B&W NUCLEAR TECHNOLOGIES

Subject: LOCA Evaluation Model Topical Report BAW-10168P

Reference: M. W. Hodges to J. H. Taylor, Request for Additional
Information on BAW-10168P, RSG LOCA, December 1,
1988.

Enclosed are revised responses to questions 8, 22, 24, 26, 27,
37, 40, 43, and 62 of the subject request for additional
information. These responses are being revised as a result of
discussions between the NRC, INEL, and B&W that have taken place
over the last several months.

Figure 62.1 SBLOCA PRESSURE FOR WESTINGHOUSE DESIGN

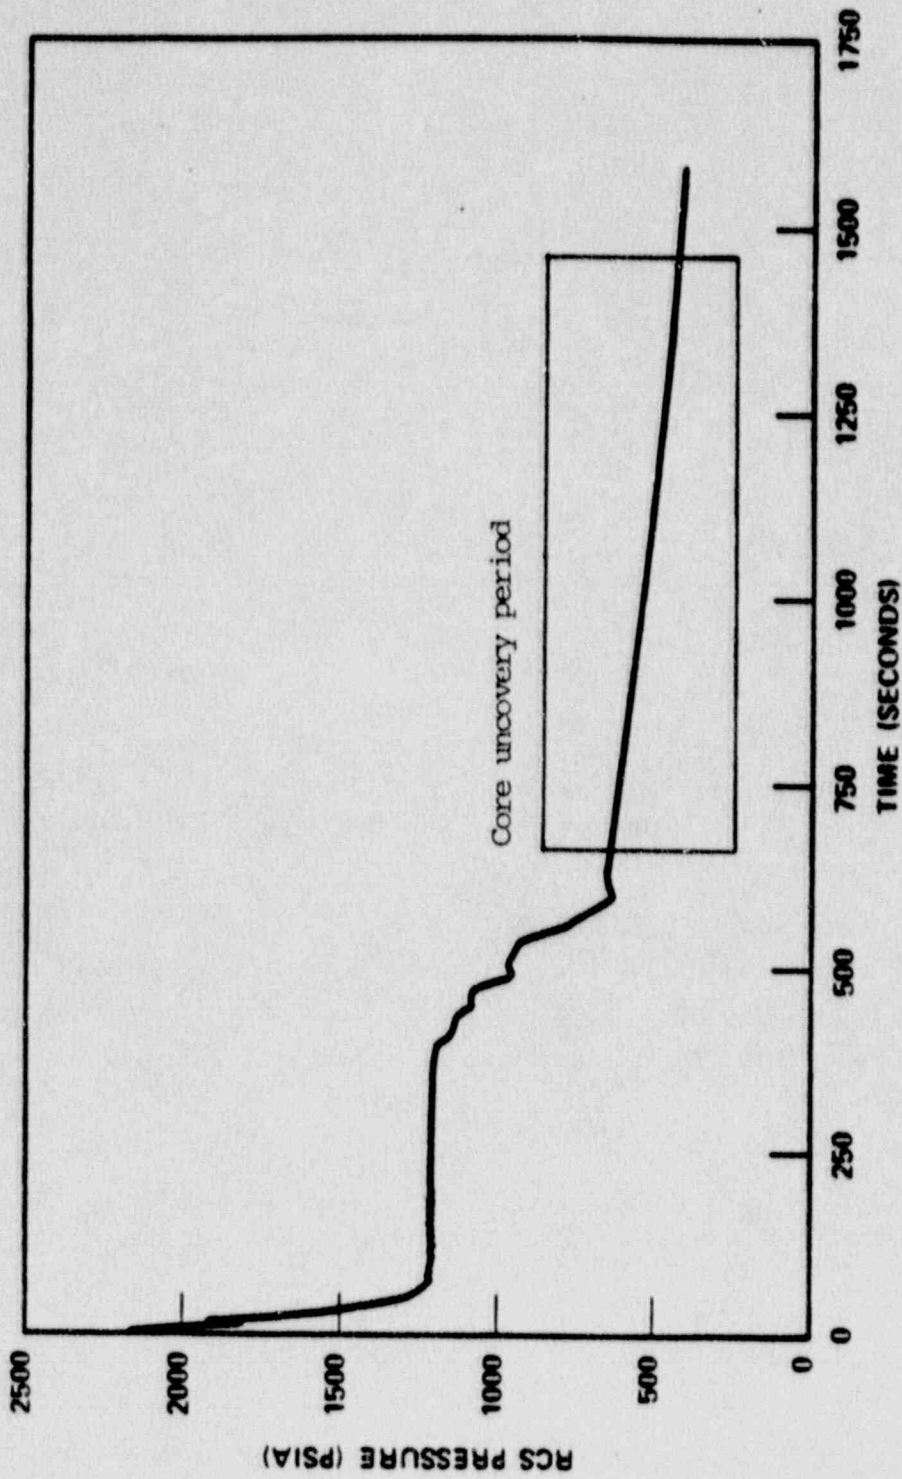
62. Question: Item I.D.2. of Section 4.4. stated that containment pressure was not a critical factor for SBLOCA's as long as the value used was reasonable. Will the value used be justified on a plant specific basis? If not, provide additional information to clarify B&W's approach to meeting the Appendix K requirement. This includes a discussion on what is meant by a "reasonable value", the containment pressure B&W intends to use, and justification that this pressure is applicable to all the plants to be analyzed.

Response: Most small break LOCAs experience only critical or choked break flow and all SBLOCAs spend most of the transient under conditions of choked flow. Figures 62-1 through 62-2 show system pressure histories for representative SBLOCA transients taken from FSARs for plants designed by Westinghouse and B&W. The timing of the occurrence of peak cladding temperature is indicated by a small box on each curve. Current PWR containment designs have LOCA pressures that range from subatmospheric to 50 or 60 psia. As can be seen from the pressure ratio between the system and the containment the leak flow for this class of small breaks must be choked for times near the occurrence of peak cladding temperatures. Thus only the larger, generally much less severe, of the SBLOCA breaks can experience subcritical flow. So long as choked flow exists, the containment pressure is irrelevant to the course of the accident. In fact, for events for which the peak cladding temperature occurs at a system pressure of 100 psia or more, the containment pressure is immaterial.
